In this paper was investigated the possibility of initial core loading pattern for iPOWER reactor, which currently is still under design stage. This is a proposed design for a suitable core that could be loaded 50% of the FA with MOX fuel and the rest of the FA with UO<sub>2</sub> fuel. The parameters such as cycle length, peaking factor, CBC, reactivity coefficients, and SDM calculation were investigated.

## Review Comments

Fig. 2. Maximum rod relative power to core average rod power as a function of burnup.

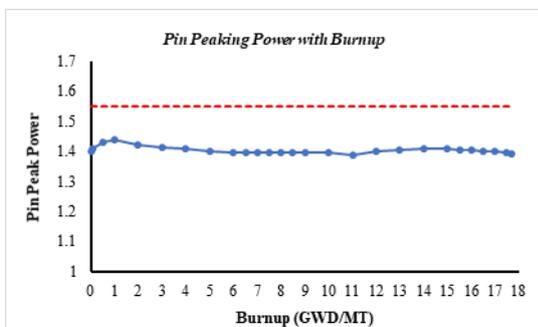
- 1) Figure 2 shows the pin peaking factors and limit value (1.55) over burnup. If you can, the safety margin and uncertainty of CASMO-4/SIMULATE-3 should be considered.

It was used 17x17 Westinghouse Fuel Assembly type; pin peaking design value limit (1.55) was considered the same as KNF company. It was not considered CASMO-4/SIMULATE-3 uncertainties, the results from the computer code use best estimate approach.

Fig. 3. Boron Concentration as a function of burnup.

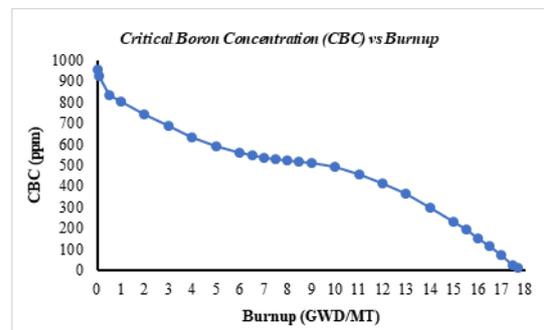
- 2) The authors said that the CBC should be less than 1000 ppm. However, the CBC at BOC looks like 1000 ppm. How can! you be sure that the design for iPOWER meet criteria?

It was applied KNF design criteria; MTC calculation showed negative results over the whole cycle operation. Shutdown margin calculation and pin peaking factor are maintained during the cycle.

Fig. 4. Moderator Temperature Coefficient in iPOWER.

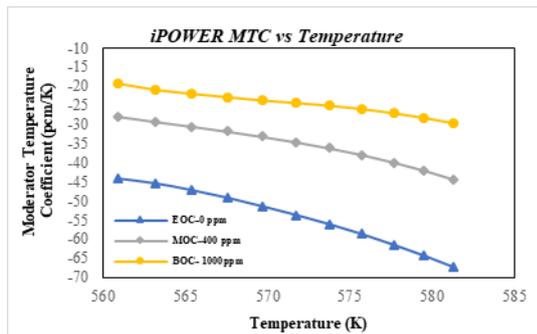
- 1) 4.2.1... "Fig. 4 contains the MTC measurements" -> "'Fig. 4 contains the MTC results calculated "

In section 4.2.1, "Fig. 4 contain the MTC measurement" sentence was modified as "Fig.4 contains the MTC calculation results".

Fig. 5. FTC for different values of fuel temperature at BOC, MOC and EOC.

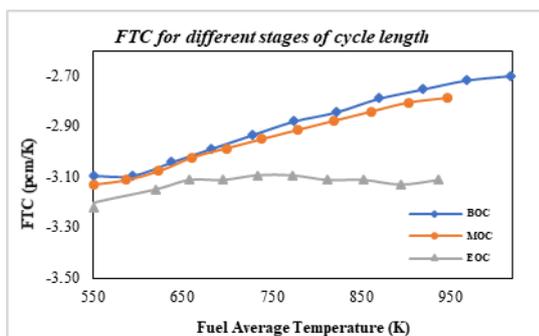
- 2) 4.2.2... "were applied to measure the FTC" -> "were applied to compute the FTC"

In section 4.2.2, "were applied to measure the FTC" statement was replaced for "were applied to calculate the FTC".
